June 12, 2018

**ADDENDUM No. 2**

**Request for Proposals CS-18-04  
REMOTE MONITORING SYSTEM FOR  
CANOE VALLEY RECREATION CENTRE AMMONIA PLANT**

AFRENA REFRIGERATION ELECTRICAL SCHEMATIC

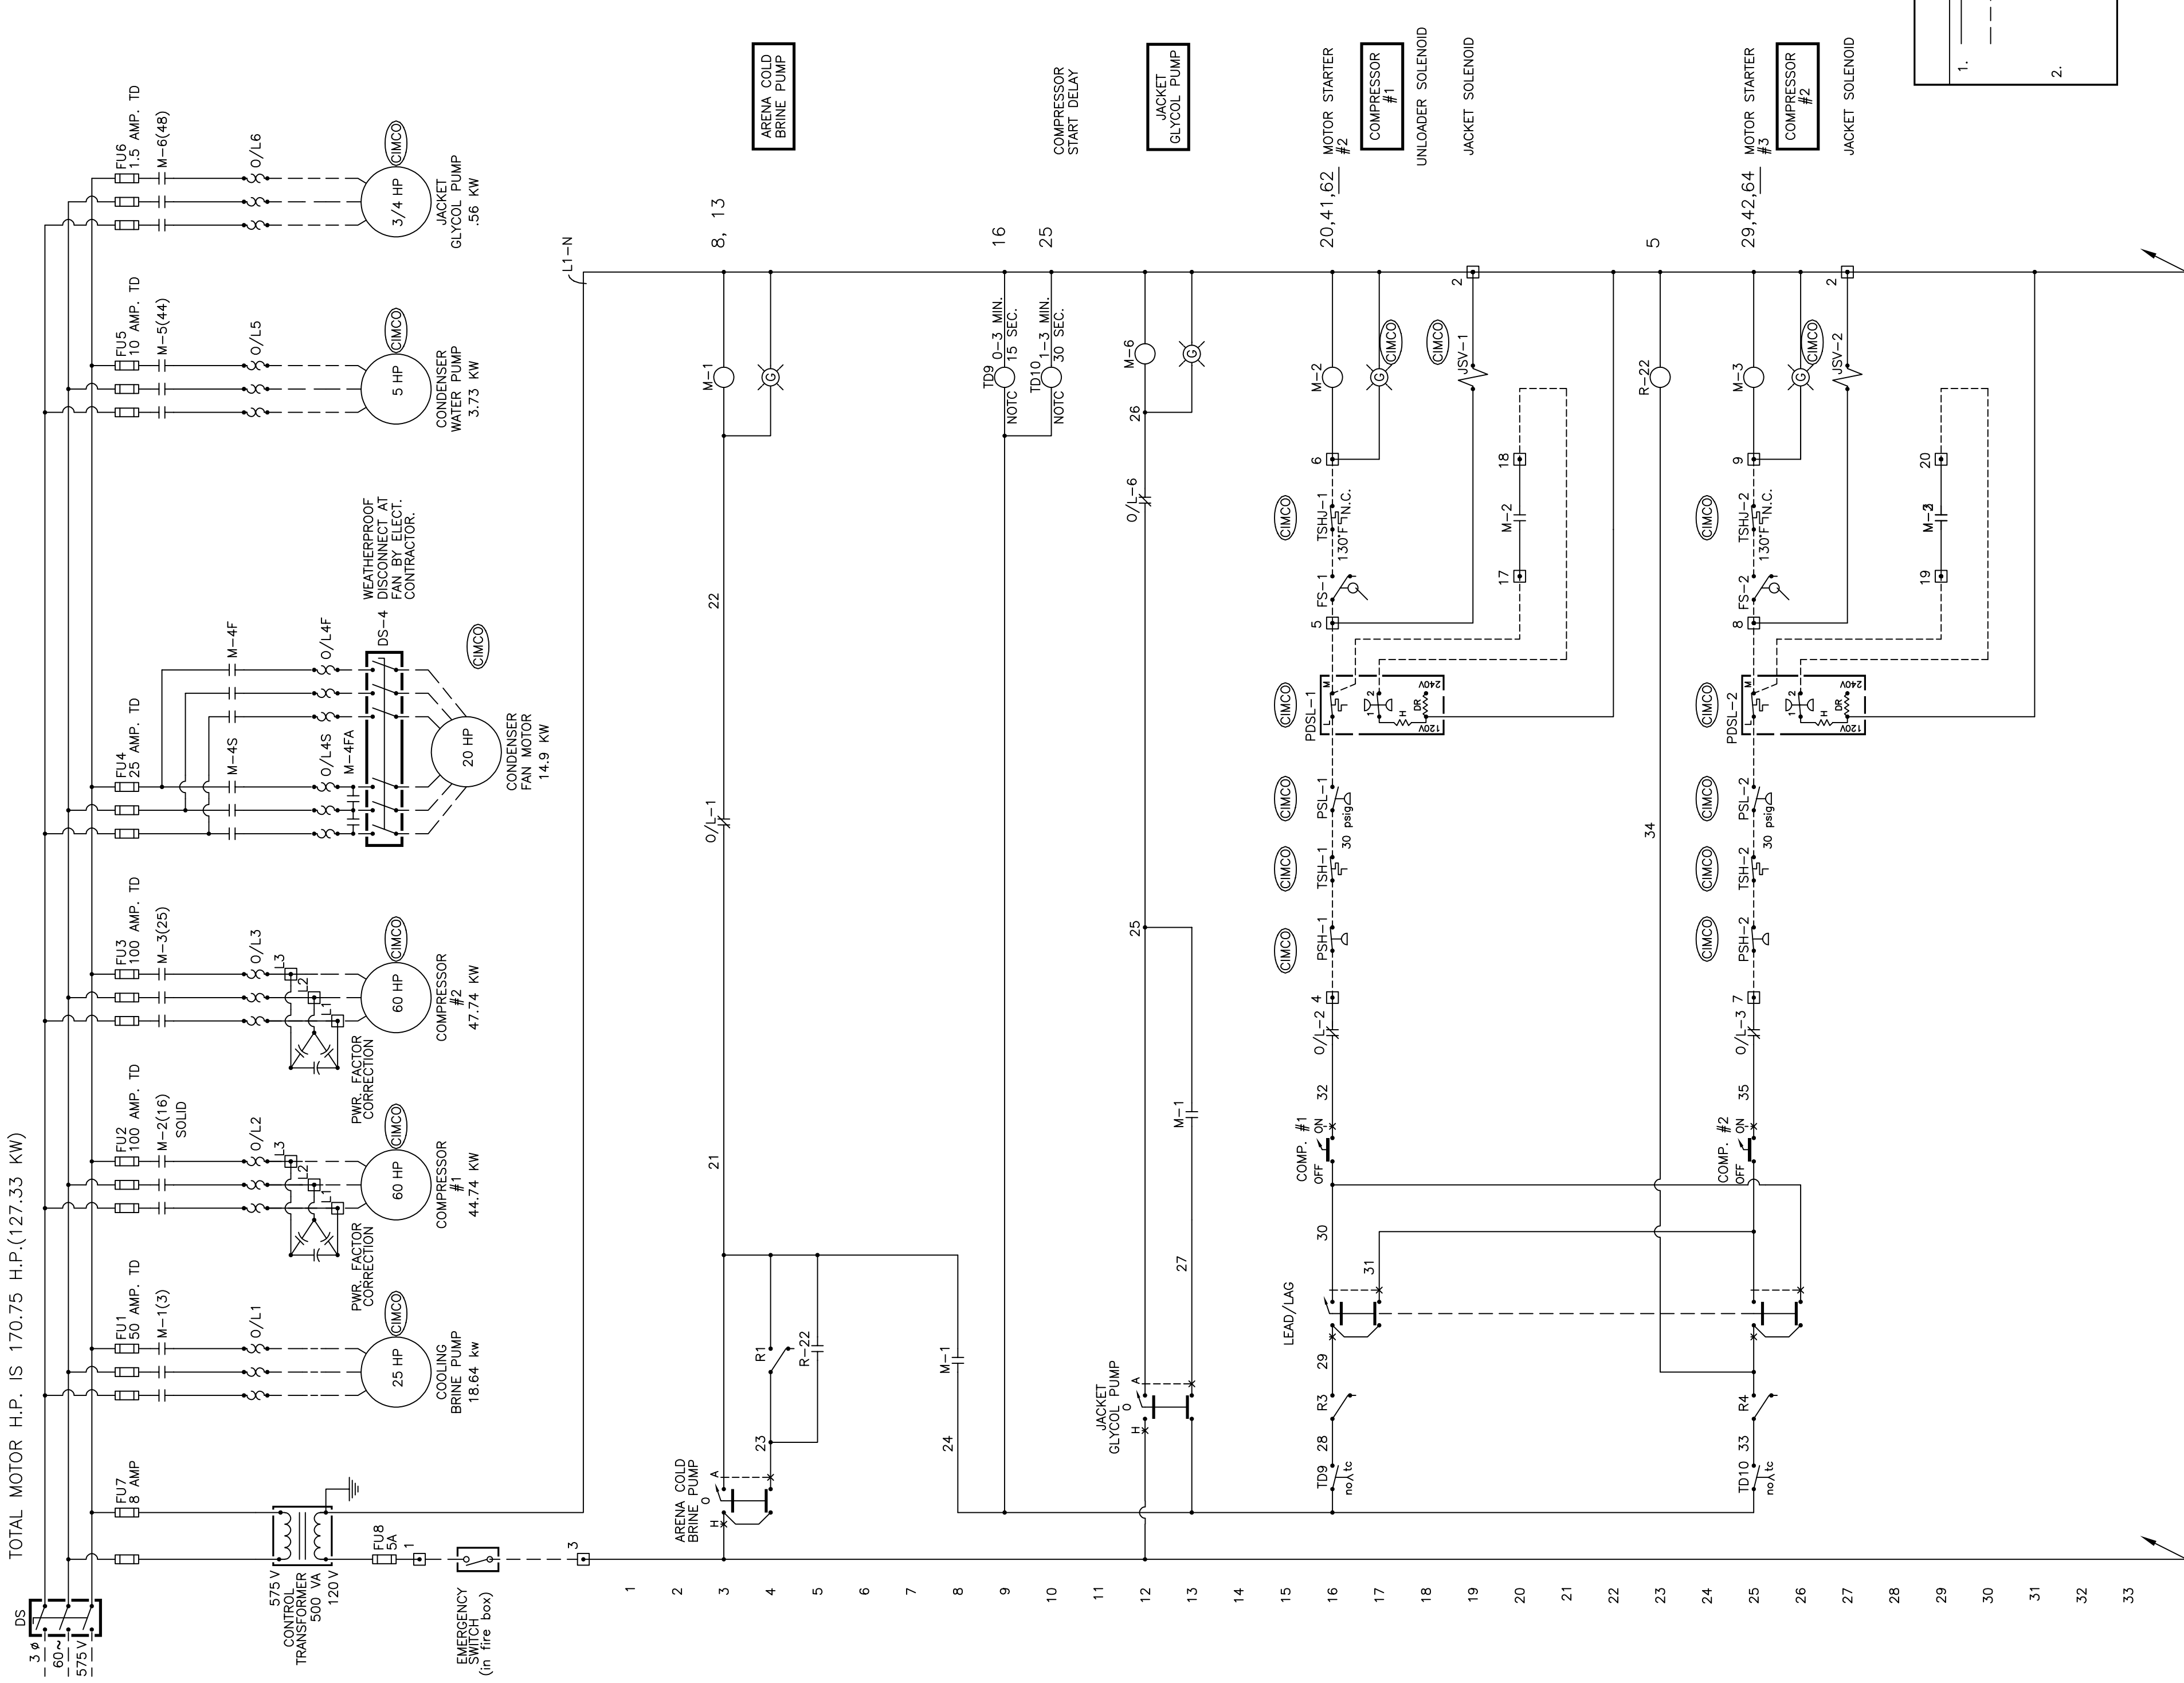
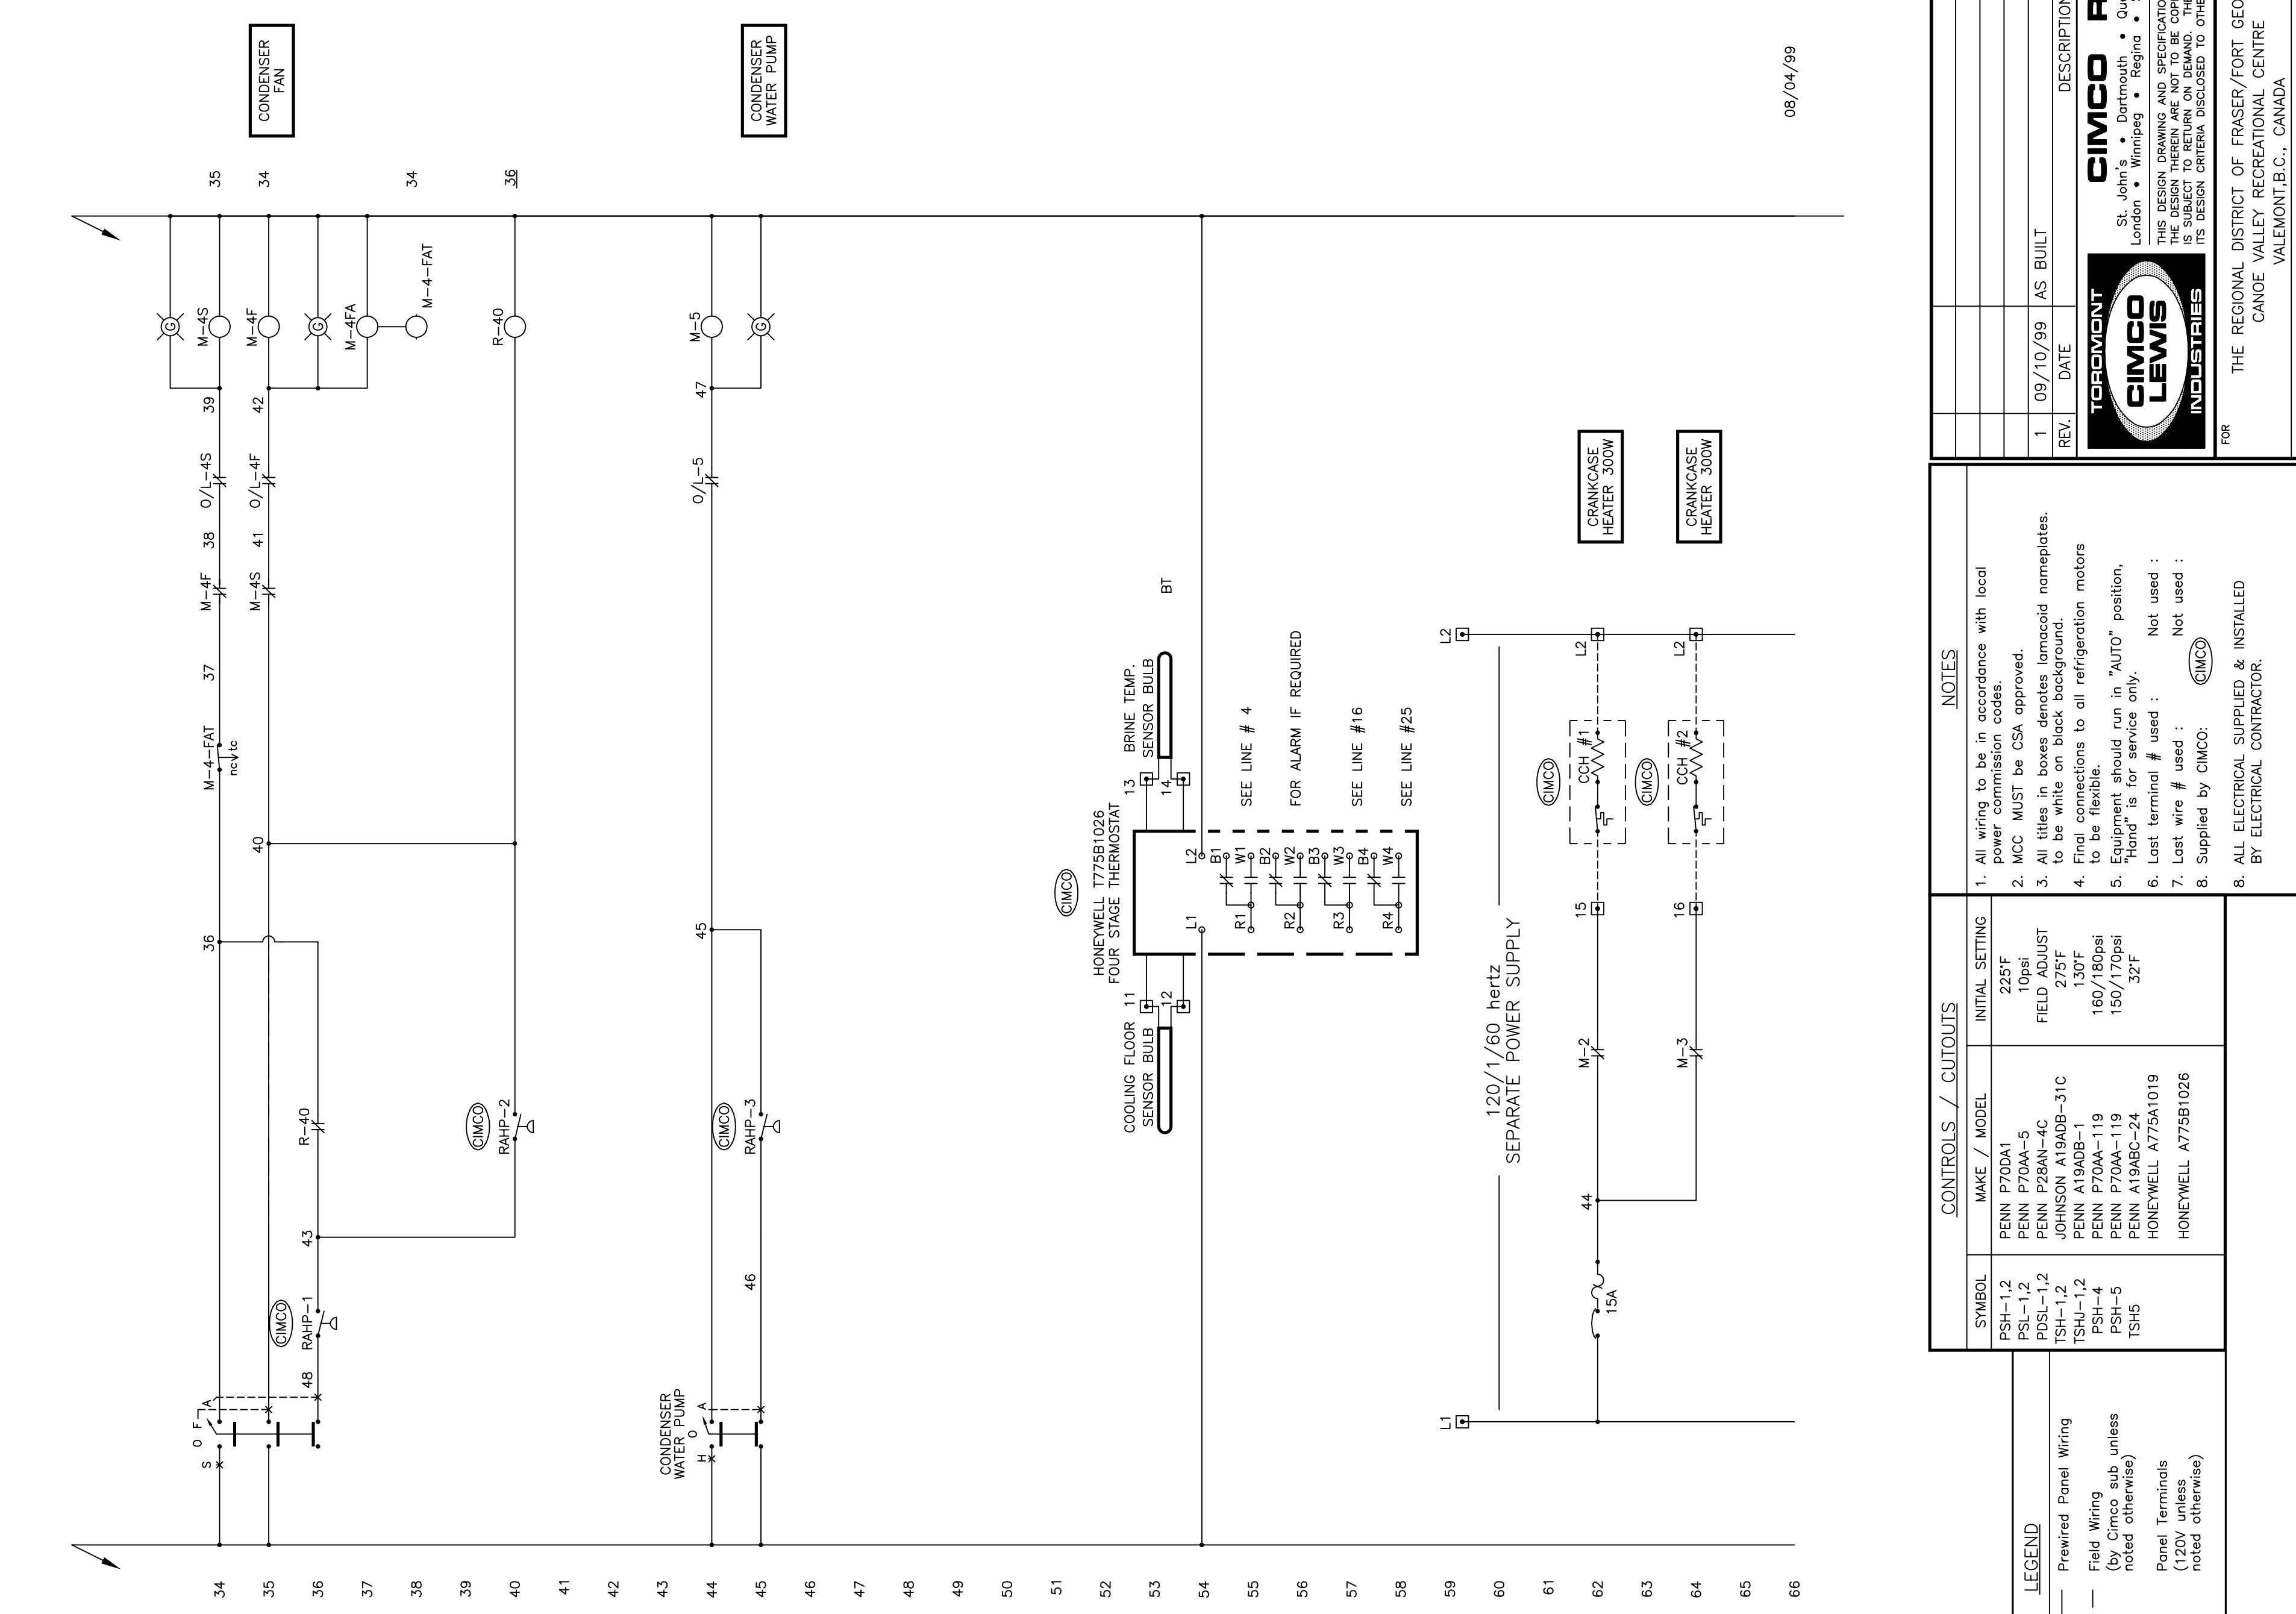
1) Are the schematics available?

**Regional District's Response: Schematics are now available, please see the attached file.**

**Due to the age of the drawings, the Regional District advises that they may not accurately reflect the equipment installed in the ammonia plant. The Regional District and the author of the drawing do not and will not accept any responsibility for any costs incurred by any party who relies on the accuracy of the drawings.**
